METROPOLITAN GOVERNMENT OF NASHVILLE AND DAVIDSON COUNTY

STAFF RECOMMENDATION

1800 Holly Street
May 21st, 2014

Application: New construction—outbuilding; Conversion—detached accessory dwelling unit

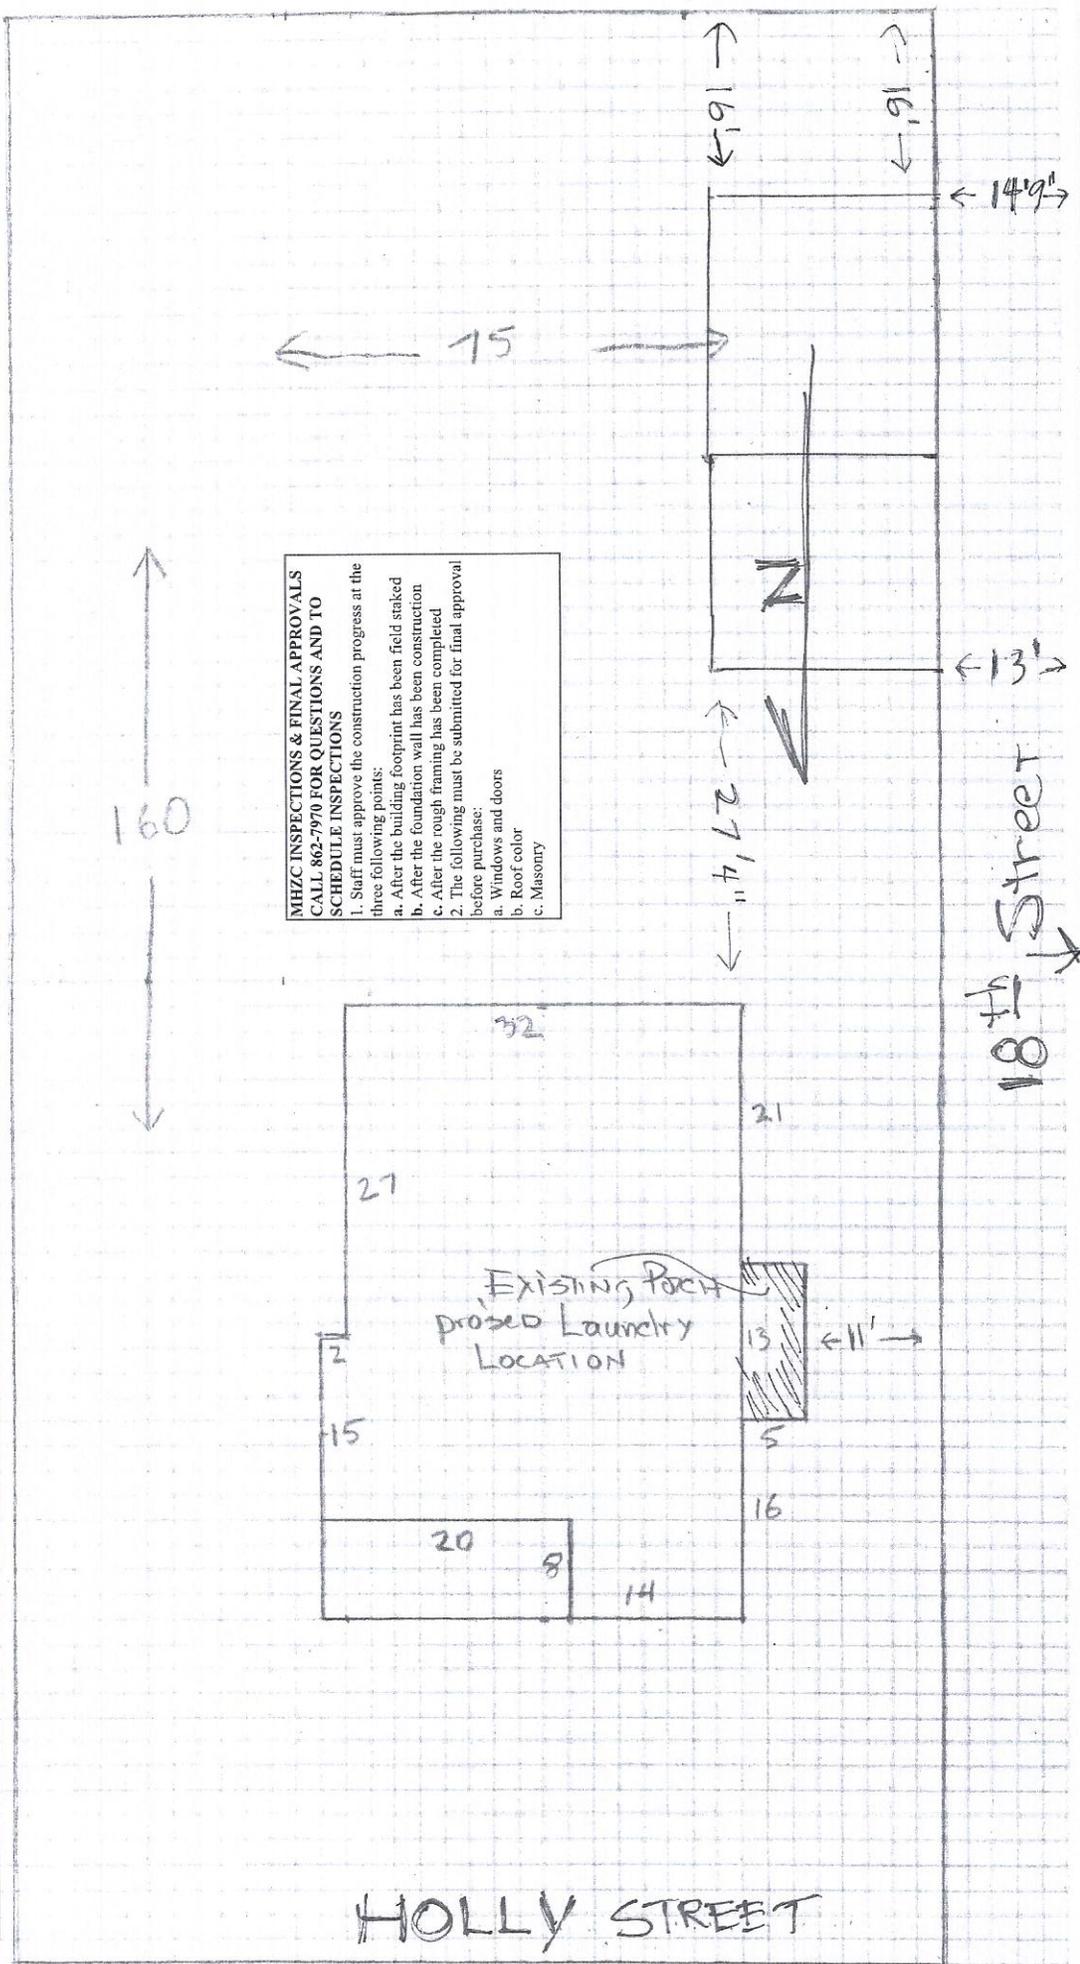
Setbacks. The proposed DADU and carport meet all base zoning setbacks. Base zoning requires that the structure be three (3') from the rear and interior side property lines, and ten feet (10') from the 18th Street property line since there are no garage doors facing 18th Street. The proposed DADU and carport will be over thirteen feet (13') from the 18th Street property line and sixteen feet (16') from the rear property line. It will be over fifty feet (50') from the interior side property line. The structure therefore meets Standard 4 of the Detached Accessory Dwelling Unit regulations.

Site Requirements. The detached accessory dwelling unit is located in the rear yard of the primary structure at 1800 Holly Street (Figure 5). There will be approximately twenty-seven feet, four inches (27'4") between the primary residence and the accessory structure. The structure therefore meets Standard 5 of the Detached Accessory Dwelling Unit regulations.

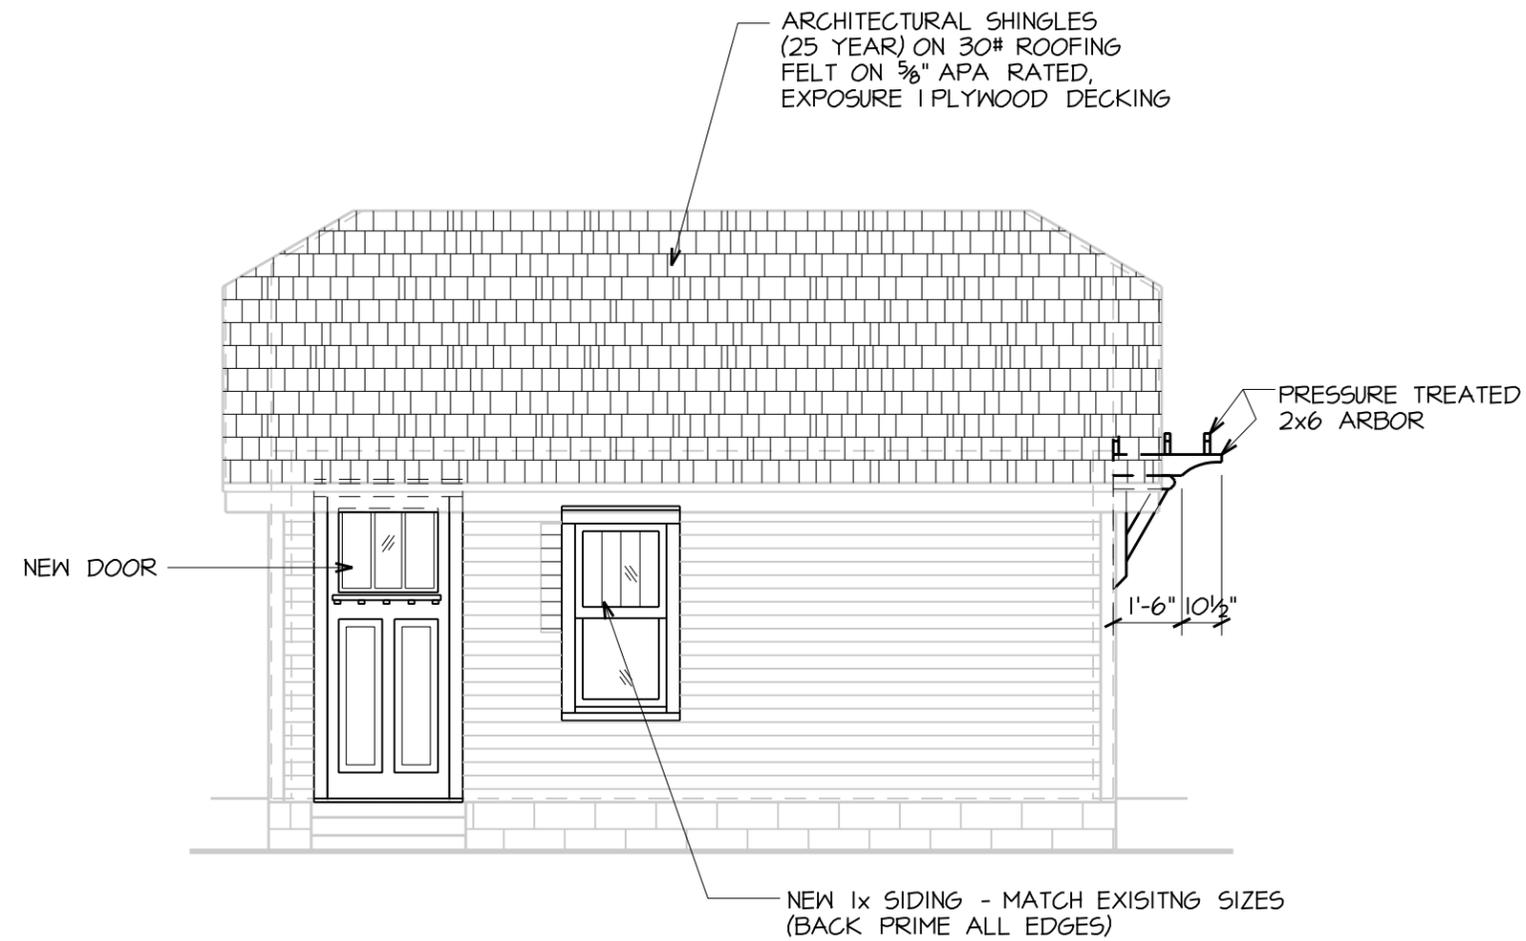
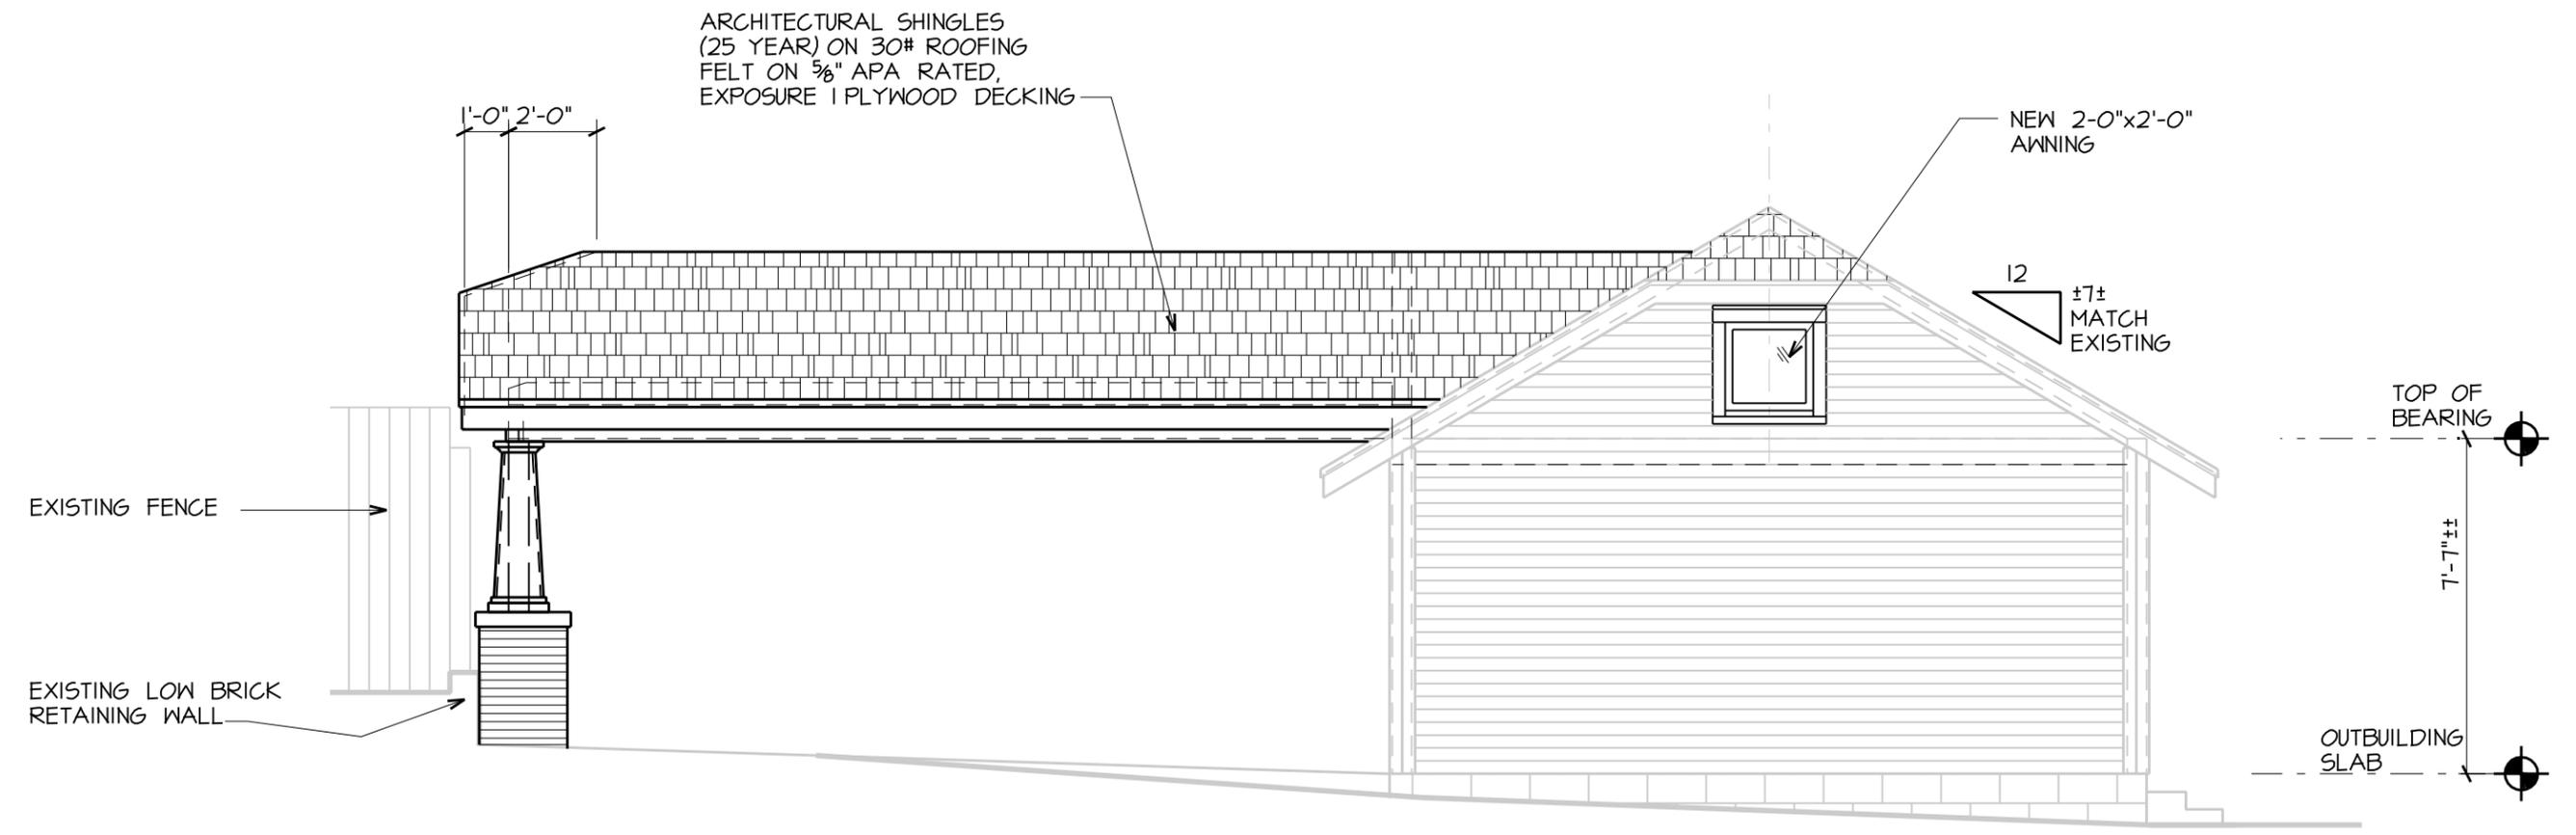
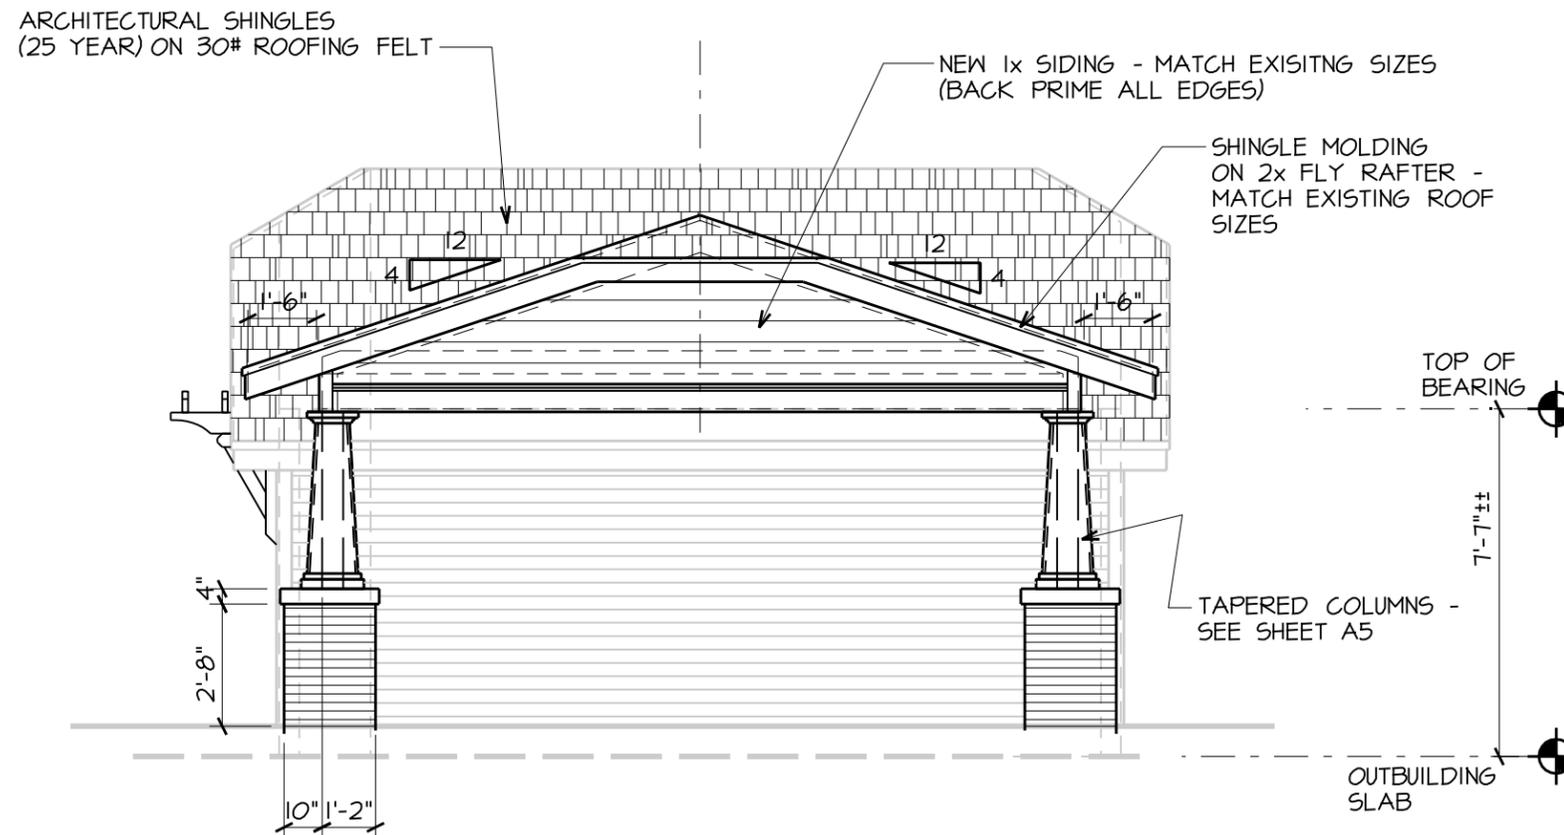
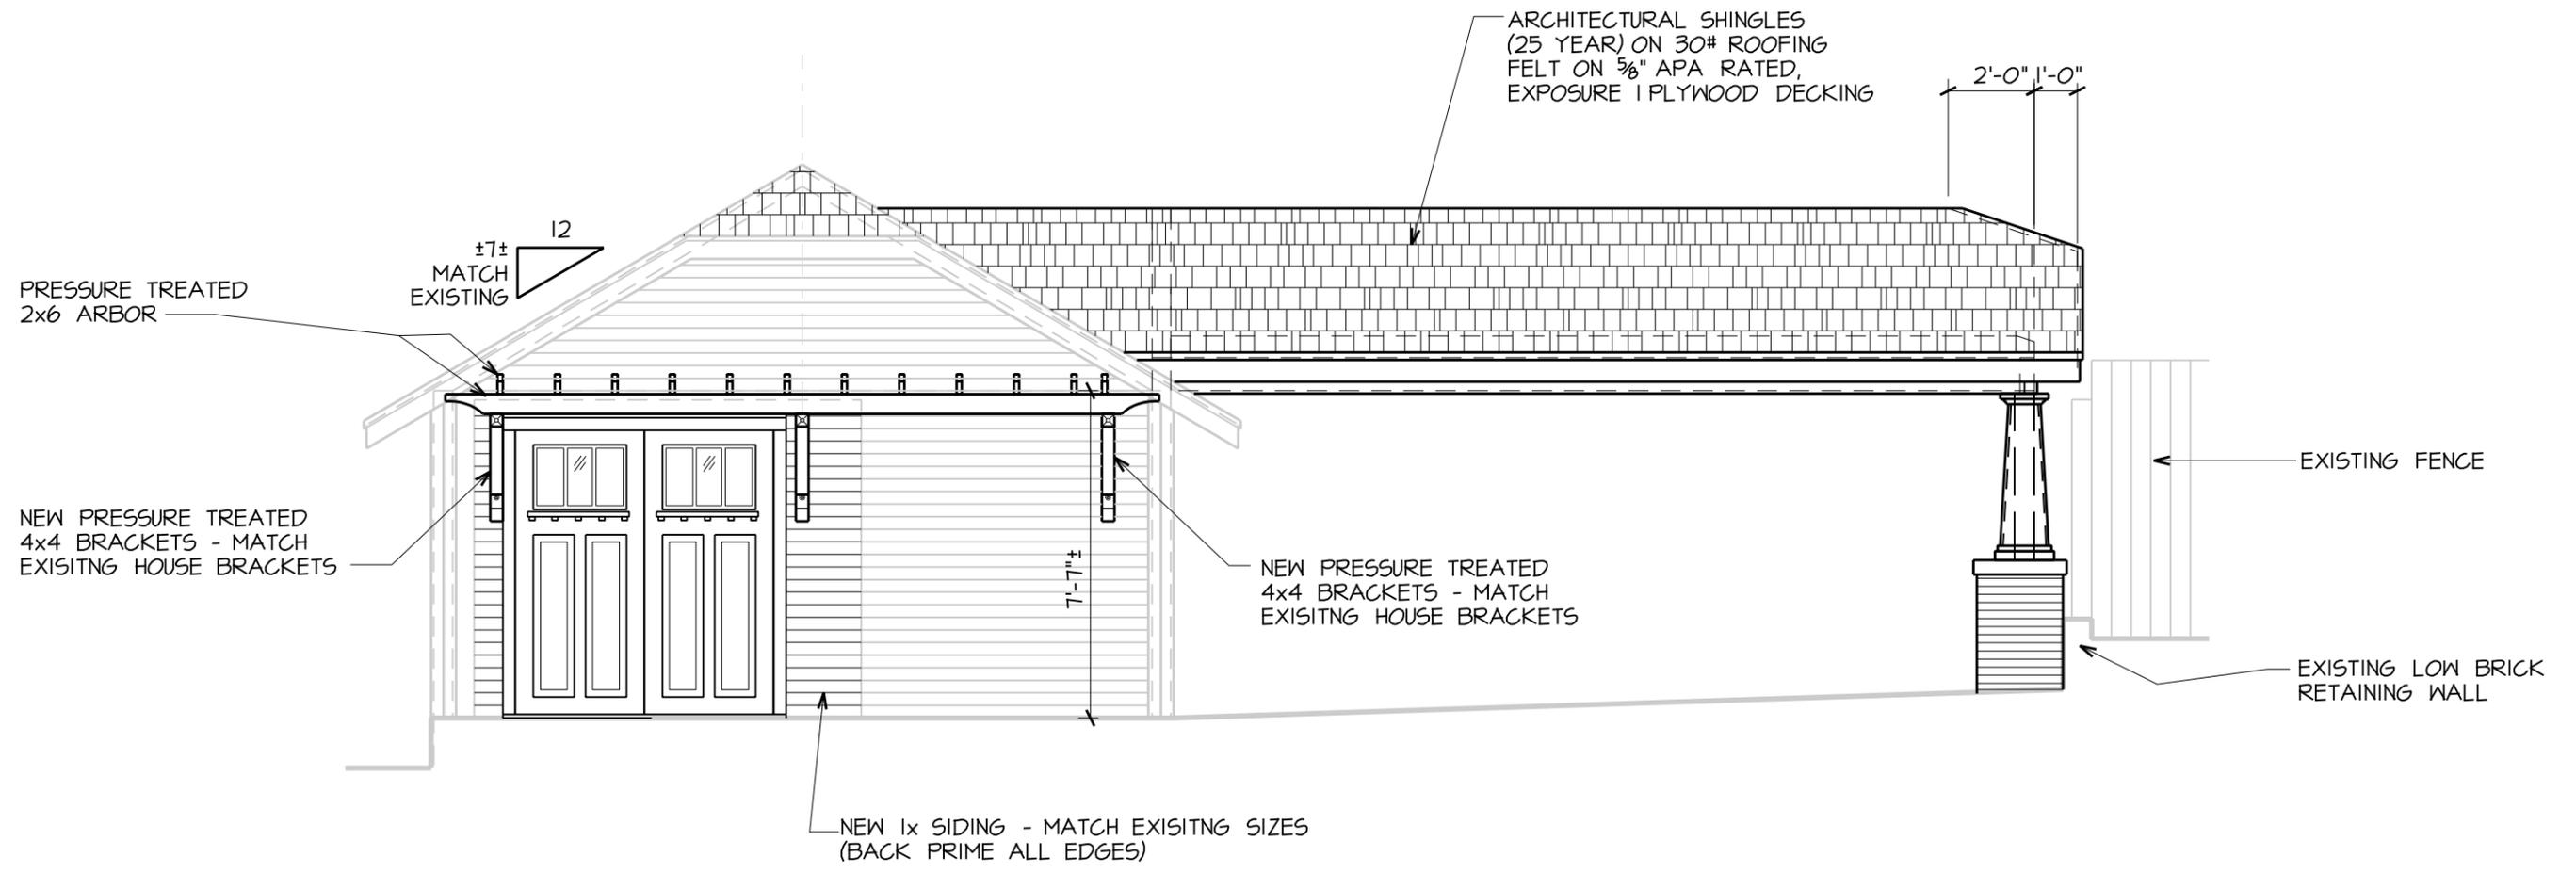
Bulk and Massing. The existing outbuilding and the new carport are both one story tall. Their combined footprint is approximately six hundred and forty-two square feet (642 sq. ft), less than the maximum footprint of seven hundred square feet (700 sq. ft.) for one-story structures. The existing structure has an eave height of six feet, three inches (6'3") and a ridge height of twelve feet, nine inches (12'9"). The new carport will have an eave height of seven feet (7') and a ridge height of eleven feet, six inches (11'6"). These eave

and ridge heights are subordinate to the historic house, which has an eave height of ten feet, six inches (10'6") and a ridge height of twenty-three feet (23'), and they are less than the maximums set by the DADU ordinance. The structure meets Standard 7 of the Detached Accessory Dwelling Unit regulations.

Materials: The existing foundation and parking pad is a concrete slab. The siding material on the existing outbuilding will not change. A pressure treated wood arbor and brackets will be added to the 18th Street elevation of the existing structure. New windows and doors will also be added to the existing structure, and staff asks to review the final window and door selections prior to purchase and installation. The roof of the existing structure and the new carport will be architectural shingles, and staff asks to approve the shingle color. The carport will have wood or cement fiberboard trim, wood columns, and brick column bases. Staff asks to approve a brick sample. The gable portion of the carport's rear elevation will be clad in wood or cement fiberboard siding to match that of the existing outbuilding. With the aforementioned staff approvals, staff finds that the materials meet section II.B.8. of the design guidelines.

Roof form: The existing outbuilding has a clipped gable roof with a slope of approximately 7.5/12. The new carport will also have a clipped gable form with a slope to match that of the existing outbuilding. These roof forms match the historic house's roof form. Staff finds that the DADU and the carport's roof forms meet section II.B.8. of the design guidelines.

1. The owner file a restrictive covenant for the detached accessory dwelling unit prior to issuance of permit; and,
2. Staff approve the window and door specifications, the asphalt shingle color, and a brick sample prior to purchase and installation of these materials.
